W3F1-97-0014

Subject: Waterford 3 SES
Docket No. 50-382
License No. NPF-38
Inservice Inspection (ISI) Relief Request ISI-017, Revision 1,
Request Authorization to Substitute Visual (VT-3) Examination for
the Code-required Surface or Volumetric Examination of the four
Reactor Pressure Vessel Support Integral Attachment Welds
(ISI Exam Number 01-074)

APPENDIX 2
RELIEF REQUEST
ISI-017, Revision 1

Relief Request ISI-017, Rev. 1
Appendix 3 (Page 1 of 2)

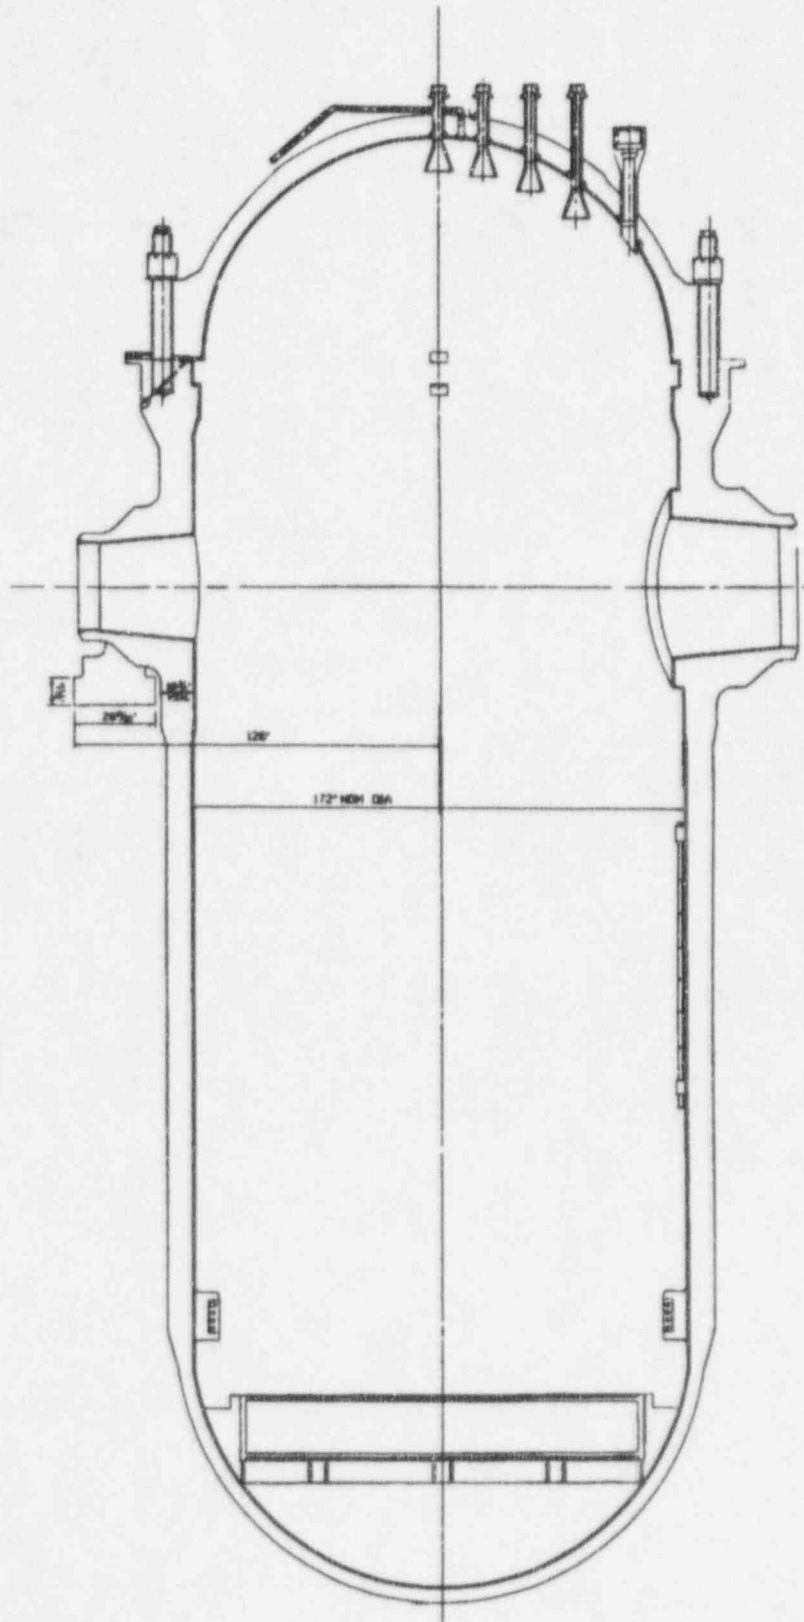
B) This request describes the limitations associated with examining the reactor vessel support integral attachment welds. However, the configuration is not adequately described. Provide a detail sketch of the examination area for this request, including all limitations.

B) The attached detailed sketches (see Appendix 3) show the Reactor Pressure Vessel Nozzles, integrally-welded attachments, supports, and interferences. As can be seen from these sketches, accessibility to the attachment welds is severely restricted even after access to the Reactor Cavity area has been obtained.
